2nd Amendment to

Performance Work Statement (PWS)

Design and Construction of a Green Infrastructure Stormwater Best Management Practice Retrofit for One or More Municipal Properties on Cape Cod – A Demonstration and Education and Outreach Project

Original: August 28, 2014
Date of 1st Amendment: July 28, 2015
Date of 2nd Amendment: October 21, 2015 (refer to pages 20-22 and 25-26)

A. Replacement of Lost/Stolen Town Sign. During construction of the Hyannis BMP, it was necessary to remove and set aside an existing Town sign. Sometime during the period of construction, this sign was misplaced, lost or stolen.

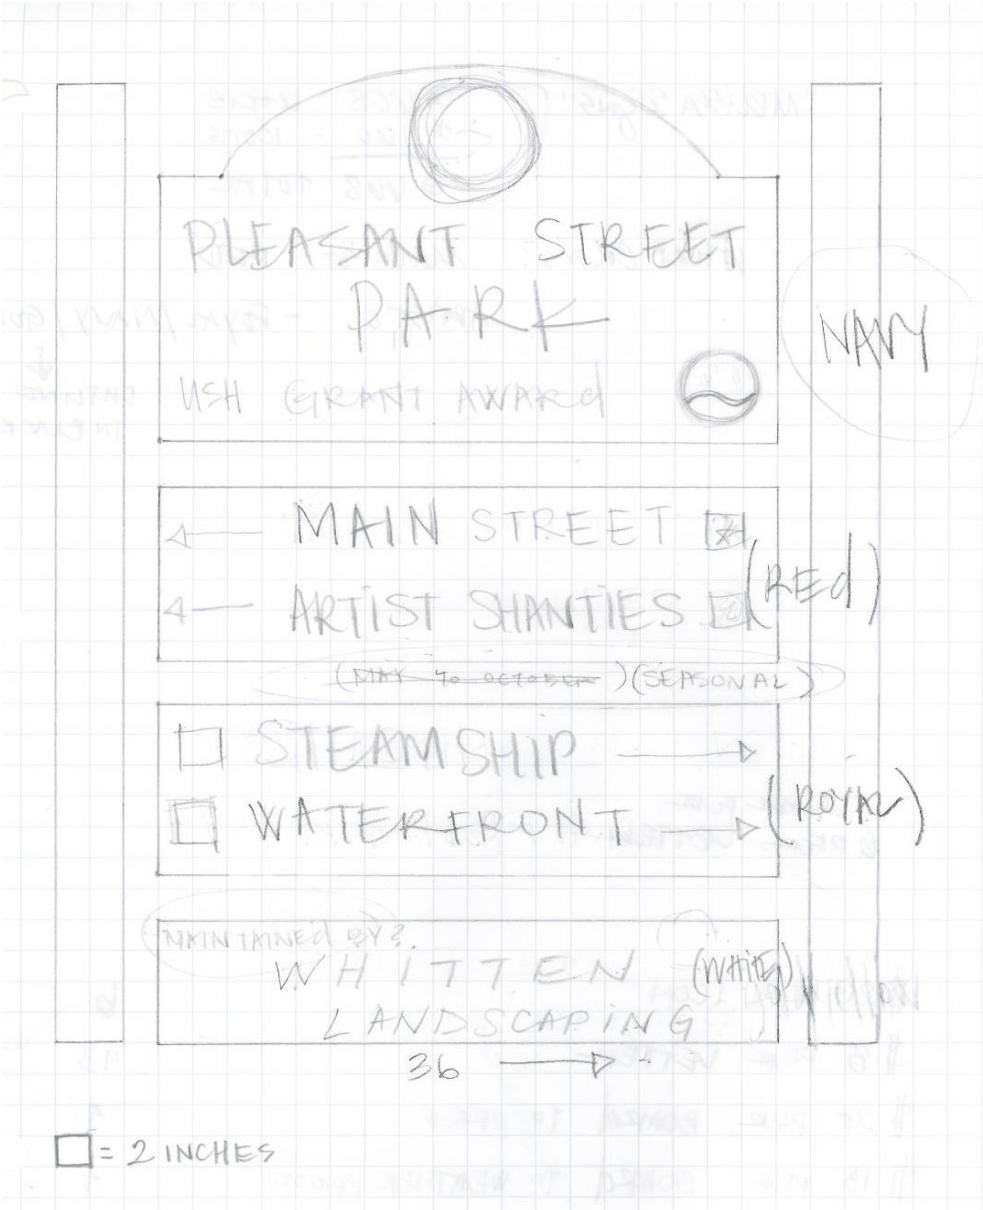
For this task, the Contractor shall provide a cost to furnish a replacement sign. For developing a cost estimate for the sign, a photo and plan are provided in the figures below. In short, the sign is a composite of four (4) smaller component signs ranging in size from 8" x 36" to 24" x 36" and where each

component sign is secured to two posts. From the diagram provided, the finished composite sign appears to be a total height of approximately 64 inches (approx. 5.33 ft'). From the photo, it is presumed the posts must be of sufficient length to be installed below the frost line.

For this task, the Contractor shall presume that installation of the sign will be provided by the Town, and that the sign must be manufactured and delivered to the offices of the Town of Barnstable DPW.

B. Installation of Replacement Sign. For this task, the Contractor shall provide an estimate for installing the sign at a suitable location identified by the town of Barnstable near the BMP.
